# CITY OF ALBUQUERQUE

**RE: 2937 Osage Ave. SW**  
**Grading and Drainage Plan**  
**Engineer's Stamp Date: 03/29/24**  
**Hydrology File: K12D040**

**LOT 6-A  
OSAGE ADDITION**

ANDRADE, ALFREDO - G & D PLAN

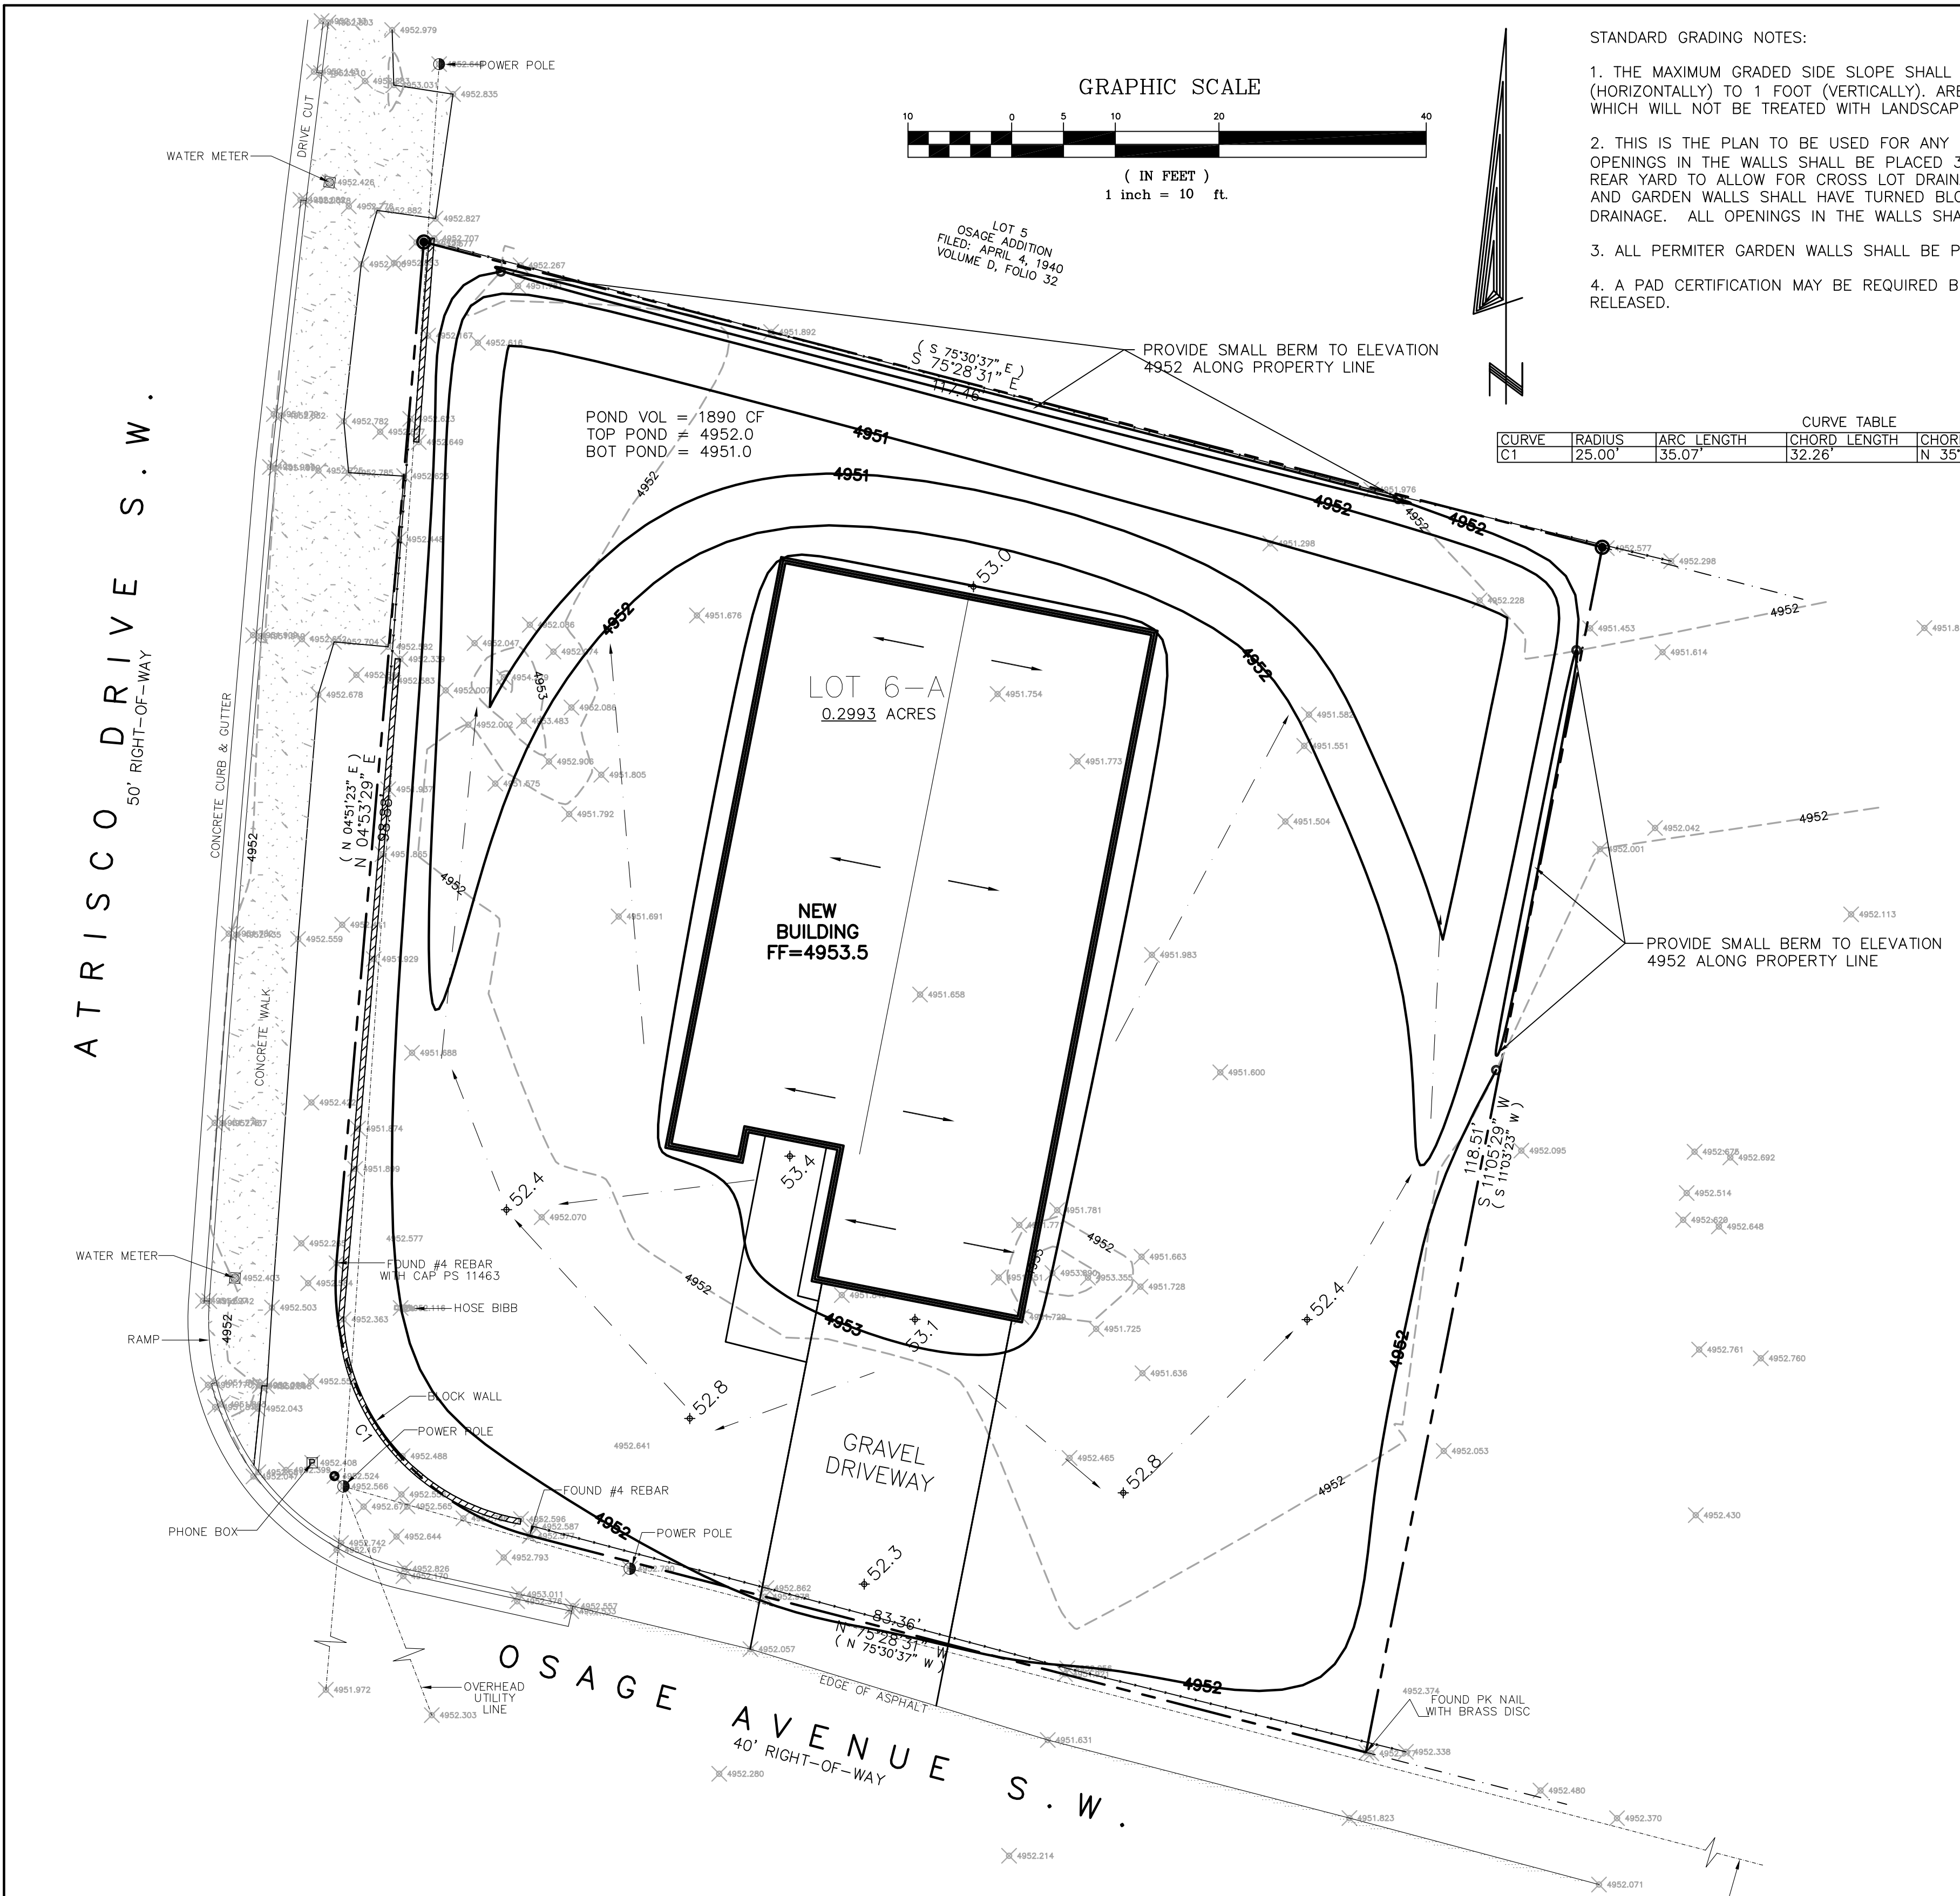
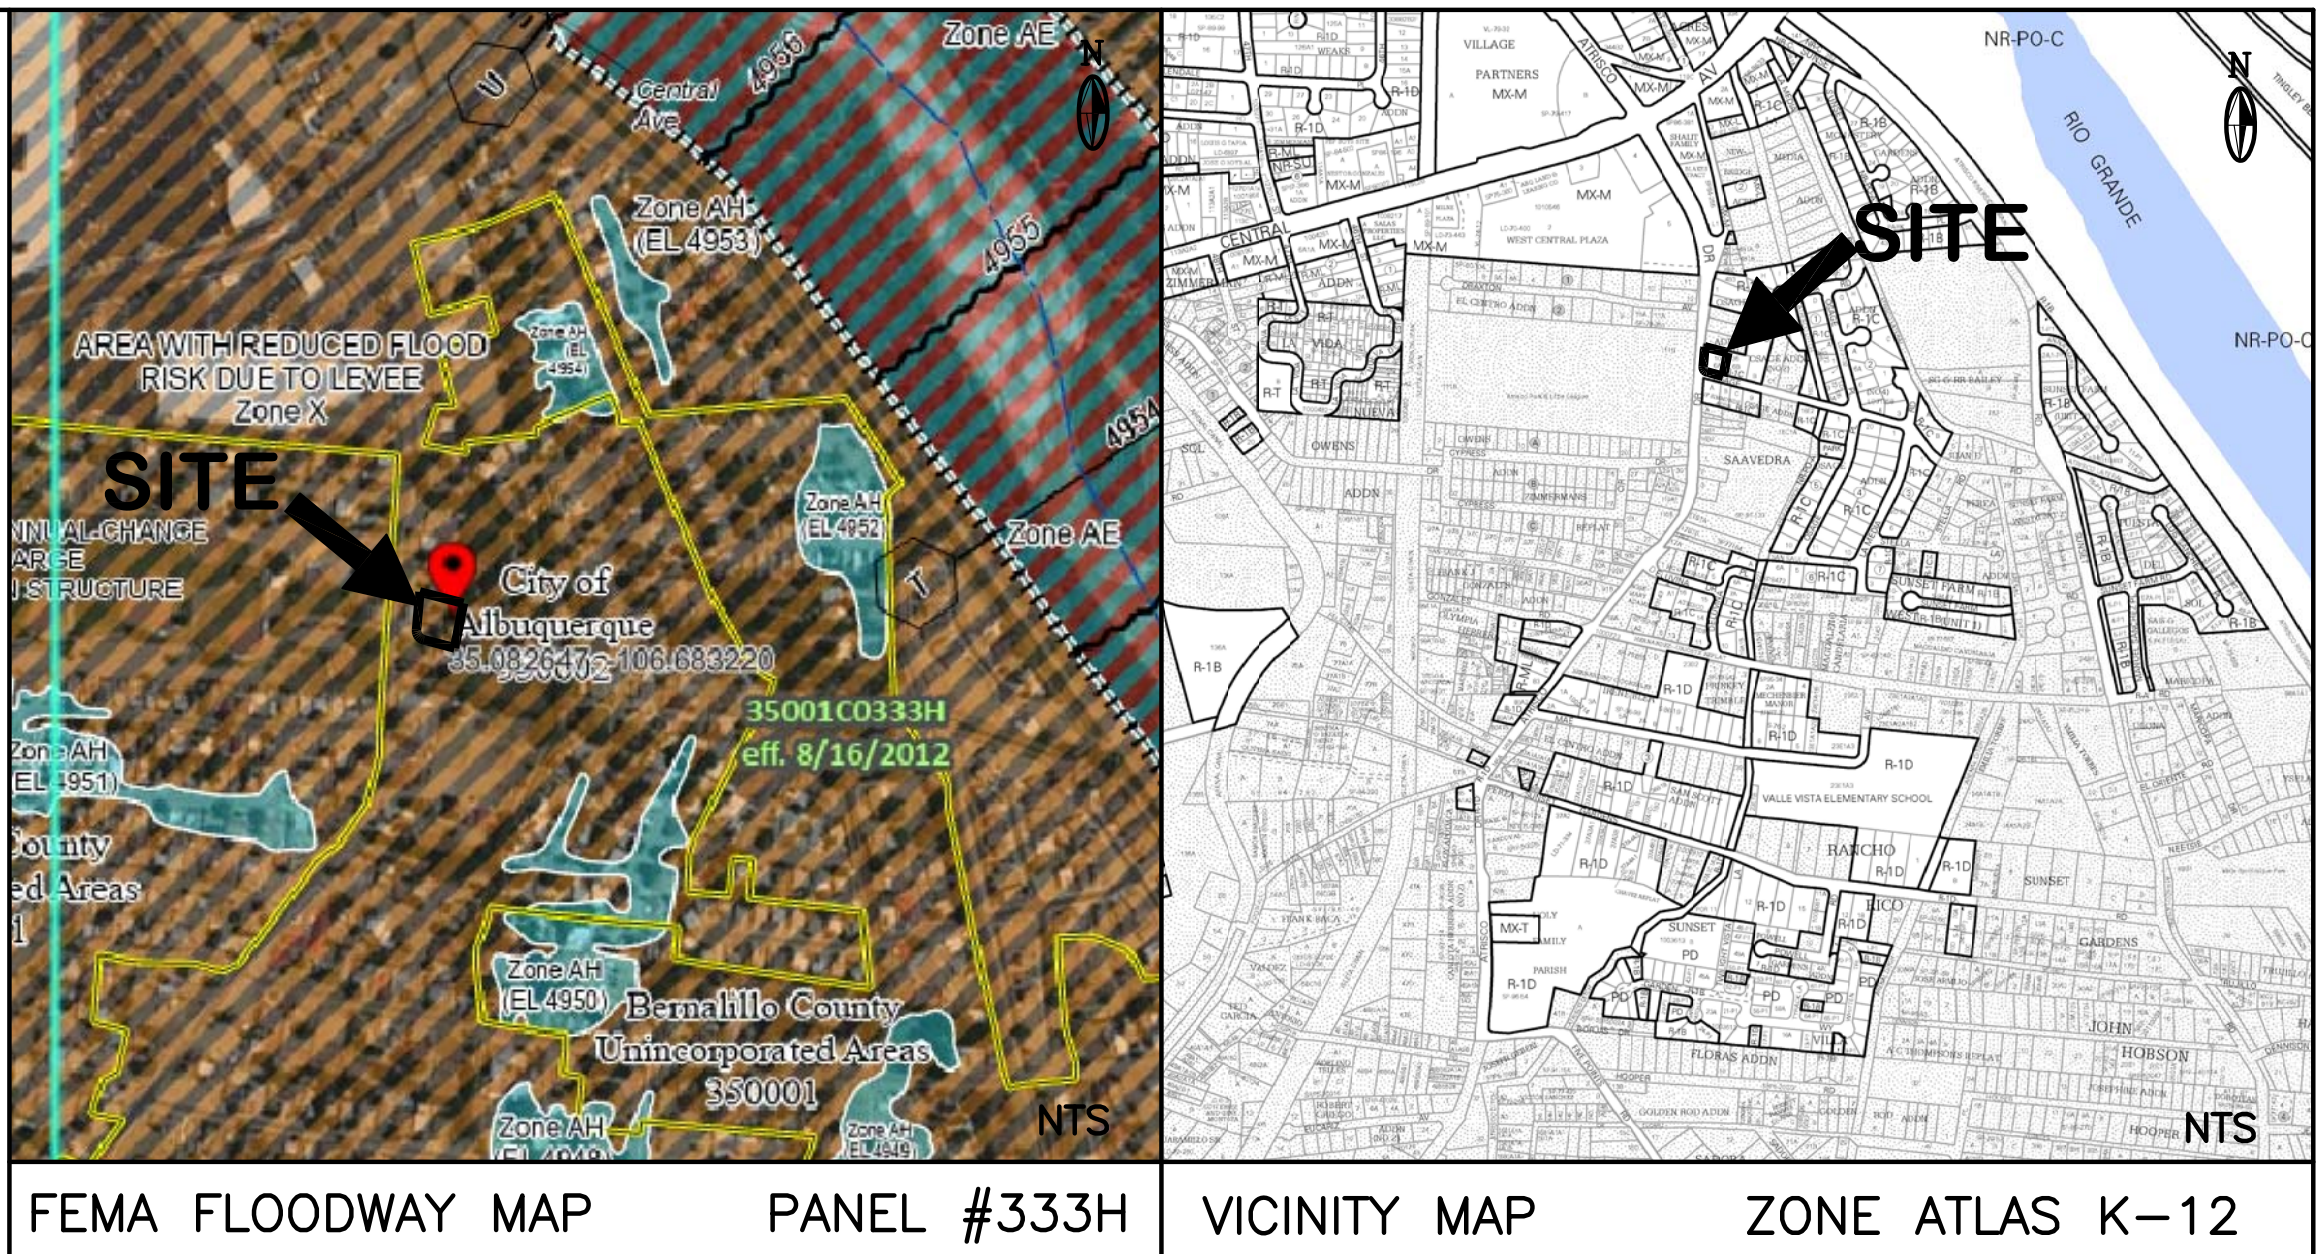
Based upon the information provided in your submittal received 03/29/2024, the Grading and Drainage Plan is approved for Building Permit and Grading Permit. **Since this site is relatively flat, a pad certification is not needed for this project.** Please attach a copy of this approved plan in the construction sets for Building Permit processing along with a copy of this letter.

1. Engineer's Certification, per the DPM Part 6-14 (F): Engineer's Certification Checklist For Non-Subdivision is required.
